John Wilkes House
Drawing No A200
Proposed Ground Floor
Scale 1:150 @ A3
Revision A
Issued 25.03.2024
Issued for Planning
Drawn by Enfield Council Architecture Team

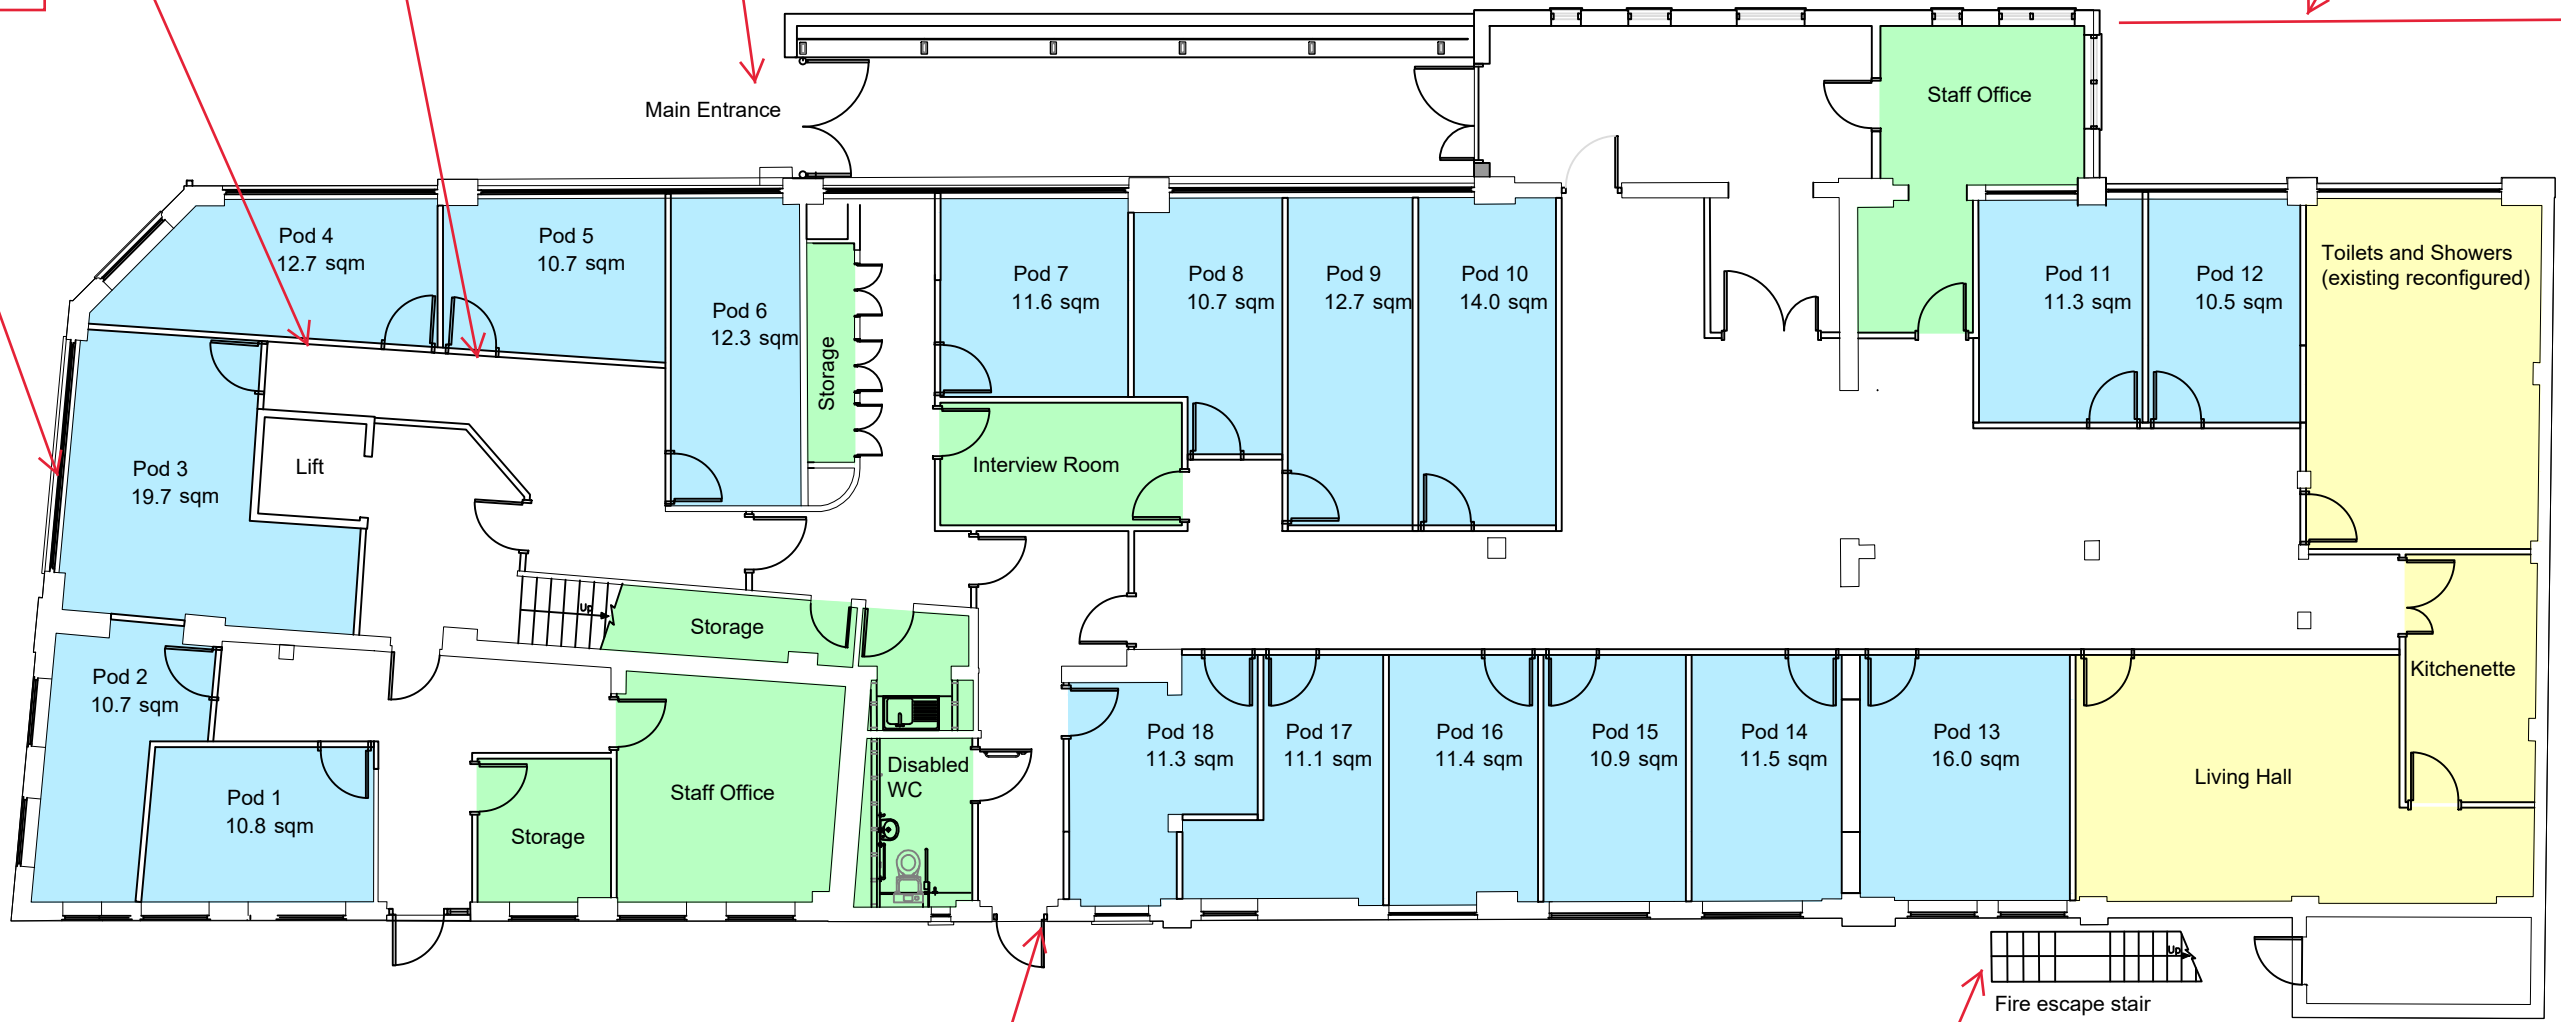
All new partition systems to be SbD accredited - DOCO to share British Gypsum system

Doors to pods to meet DOCO requirements, DOCO to confirm requirements

Photocell controlled outdoor lighting by main entrance

Area for bins to be fenced off

1.8m high obscure film to be provided to all windows to non-staff spaces

Sloped coping stone to be installed to top of planter to prevent use as a seat

Existing card based access control on communal doors

Gate required to stair to prevent access. (Escape bar required for use as escape stair)
